PCI-SIG ENGINEERING CHANGE NOTICE

TITLE:	M.2 2242 WWAN Module
DATE:	Introduced: June 3, 2014 Updated: November 13, 2014 Final Approval: November 20, 2014
AFFECTED DOCUMENT:	PCI Express M.2 Specification, Revision 1.0
SPONSOR:	Will Harris; Advanced Micro Devices

Add 2242 form factor for WWAN modules using Socket 2 with key B.

Figure 10. M.2 Type 2242-S3 Mechanical Outline Diagram Example

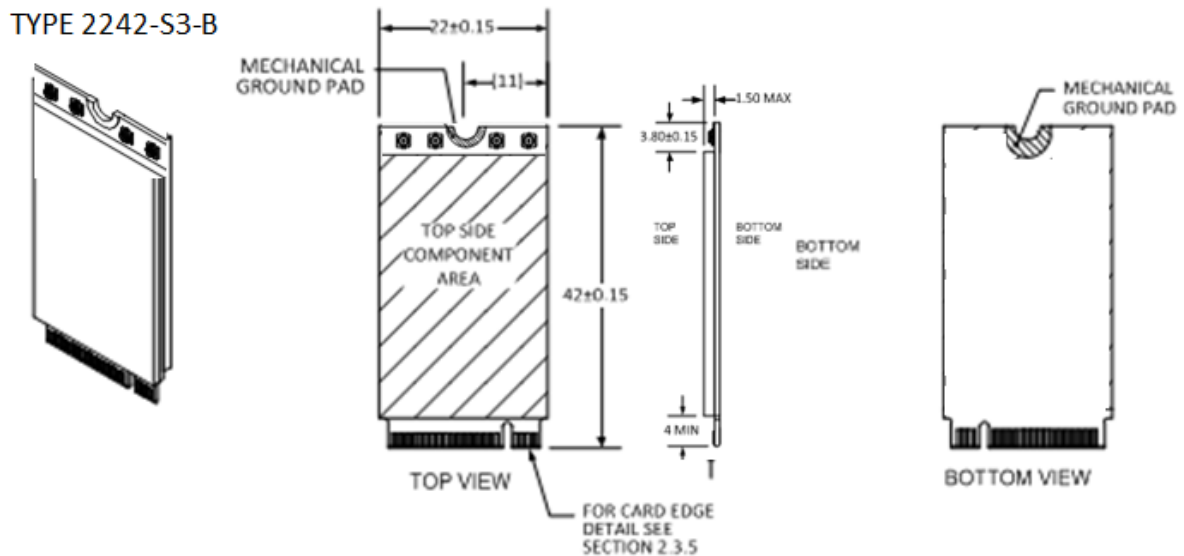
Add Chapter 2.3.2.2:

2.3.2.2 Type 2242 Specification

Type 2242 is a M.2 board/module size used on Socket 2 and intended to support WWAN solutions.

In principle the board is comprised of three sections:

- Host I/F section
- RF connector and mounting hole section
- Active Component section

The active component section is 22 mm wide with the same overall length of 42 mm like the other board/module intended for Socket 2.

An example of the Type 2242 board/module mechanical outline drawing is shown in Figure 10.

The board size supports up to four (4) RF connectors, which can be populated while maintaining the recommended 4.5 mm center-to-center distances. See section 2.3.7, RF Connectors in this document for recommended locations and assignments.
